Final authors response to '**Attributing the 2017 Bangladesh floods from meteorological and hydrological perspectives**' by Sjoukje Philip et al., 2019.

This document contains the replies to all reviewers, including the interactive discussion, and a marked-up version including
5 all changes between the first version of the discussion paper to the current final version.

Interactive comment on “Attributing the 2017 Bangladesh floods from meteorological and hydrological perspectives” by S. Philip et al.

Interactive comment on “Attributing the 2017 Bangladesh floods from meteorological and hydrological perspectives” By S. Philip et al.

Autocorrelation of Jul-Sep precipitation pr CPC Brahmaputra (iprcp cpc daily mask0 su) 1979:2017

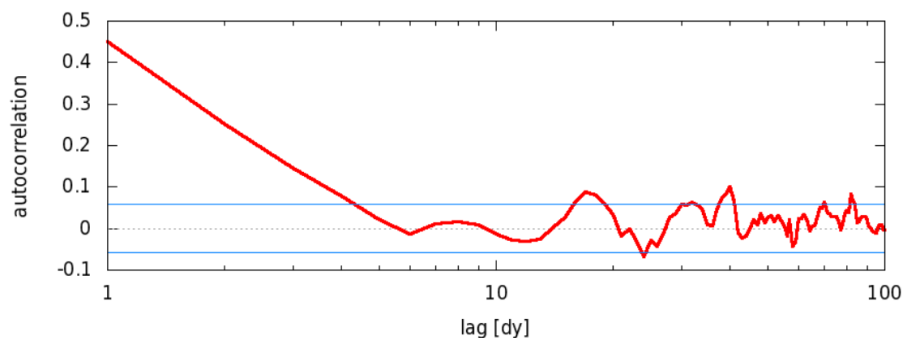
Add some details into the Statistical methods for trend detection. Time series of parameters are may be autocorrelated (temporal dependency over times scales of several years). I am wondering whether the authors took these autocorrelations into account or not.

We checked the autocorrelation and found that there is no autocorrelation of the July-September maximum of 10-day mean precipitation, which is the measure we use in this study. (And for single days the autocorrelation becomes negligible within 4 days.) Therefore, we will add in the Statistical methods section for trend detection: We checked that year-on-year autocorrelations of RX10day are negligible, so serial autocorrelations are not a problem in this analysis.

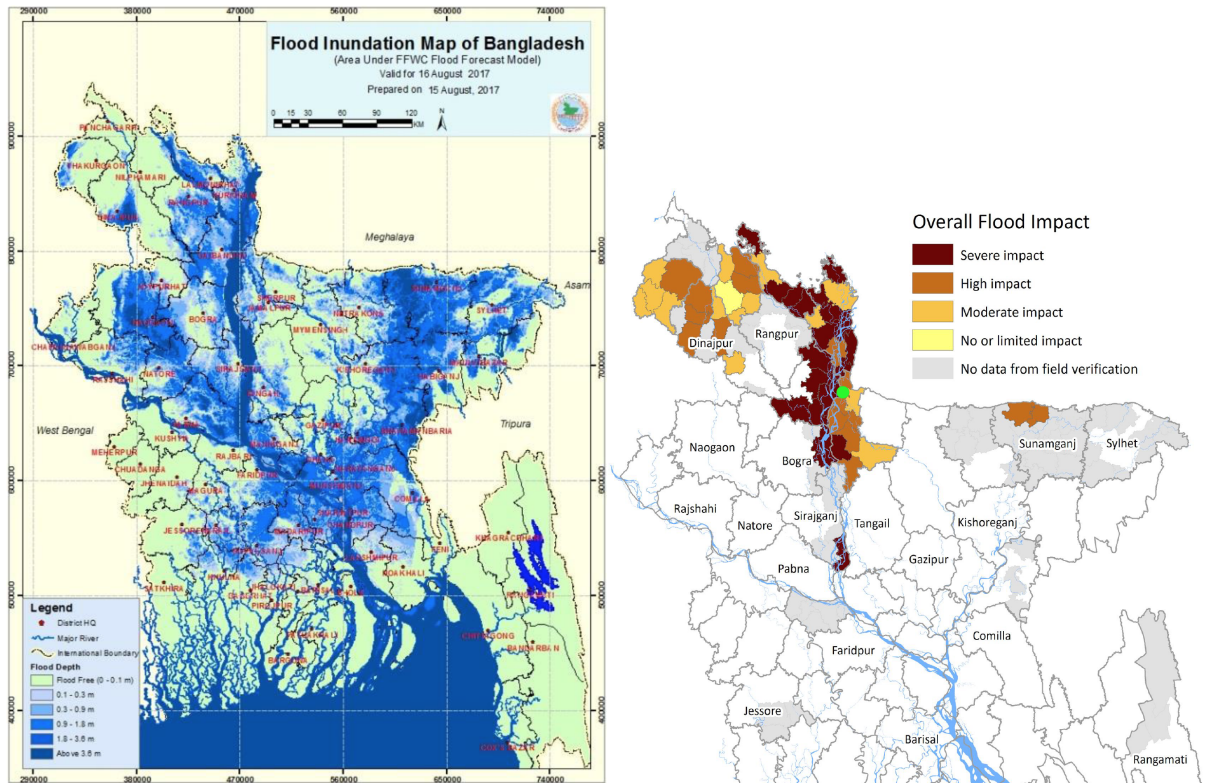
3) Many careless parts for reader. Explanations are insufficient and cannot understand the explanations in many parts. I would like to ask brush up the paper again, such as;
> Where is a green circle, Brahmaputra, too small words in Fig.1

As stated clearly in the figure caption both of these panels are reproductions of figures produced by a 3rd party and as such we are unable to edit these. The links to the original documents are provided where the reader can enlarge the figure reproduced. The green circle is clearly visible along the Brahmaputra river at the NW of the map shown. We added that the green circle is in the northwest of the map.

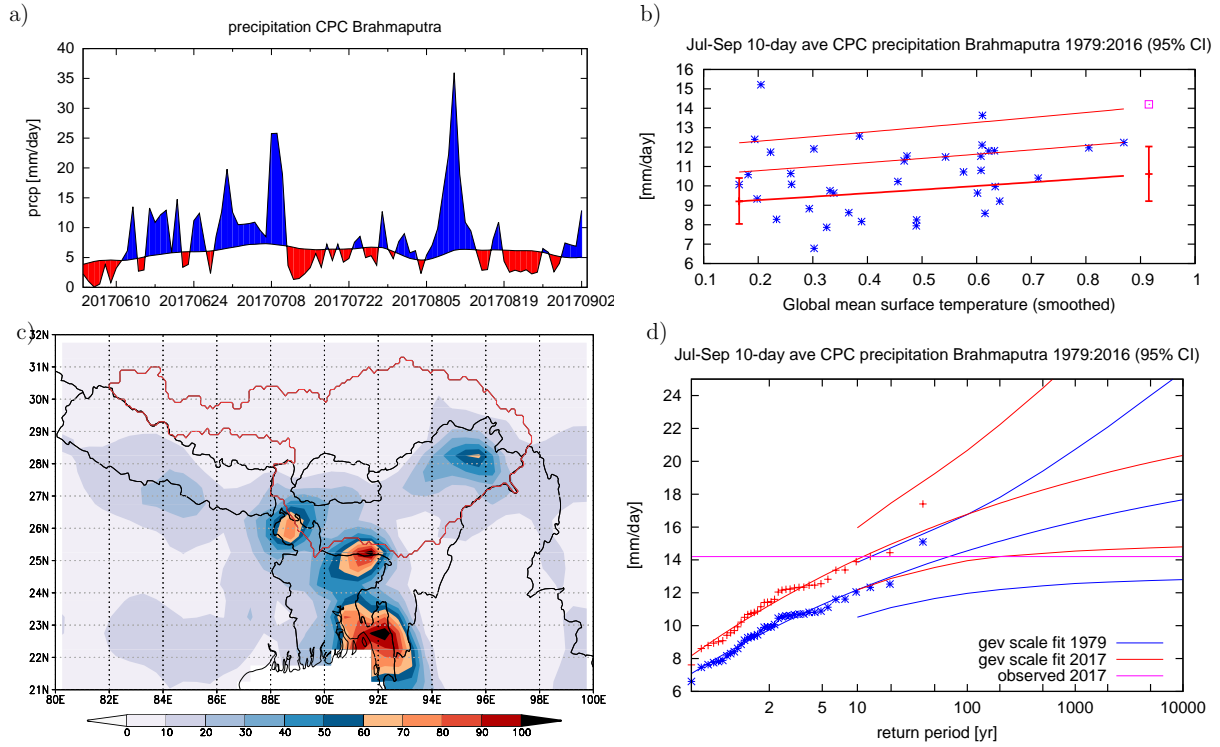
Several figures are shown without explanation, such as Fig.3b, Fig.5a, etc.

Fig3b is described, we apologize for mixing up the order of description in the caption and corrected that. We checked that Fig.5a already has an explanation. We could not find any other panels without explanation.
